Product Change Notification

1. ECN #: 265473

3. Series:

- TFM - .050 X .050 MICRO STRIPS
- TFML - .050 SHROUDED TERMINAL

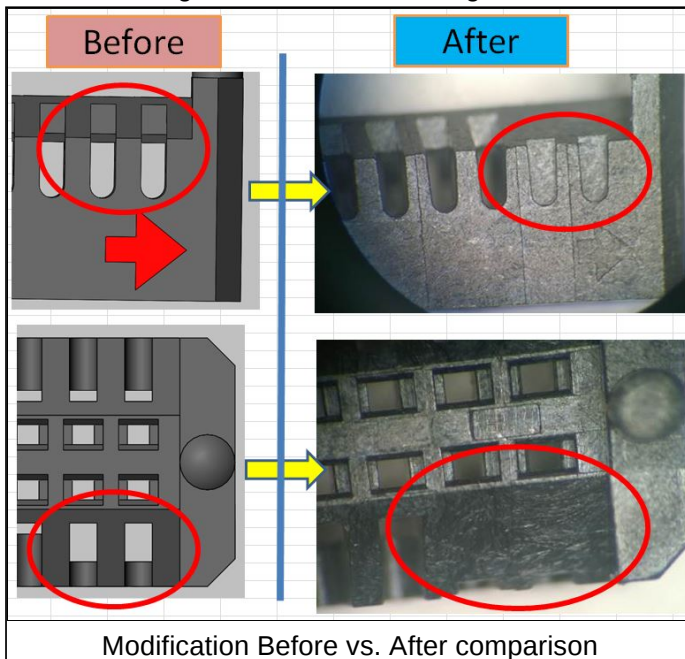
The voids at the keying notch location are being changed from visible(open) to blind(closed).

The void change is visible without magnification from inside the part and outside the part.

The current steel design has a poor shut-off condition that requires additional maintenance to manage the flash in the windows. Removing the void in this area eliminates any need for this additional maintenance and eliminates the risk of flashing in this area.

- Form - The voids in the keying notch location are being removed and would be considered only a visual change.
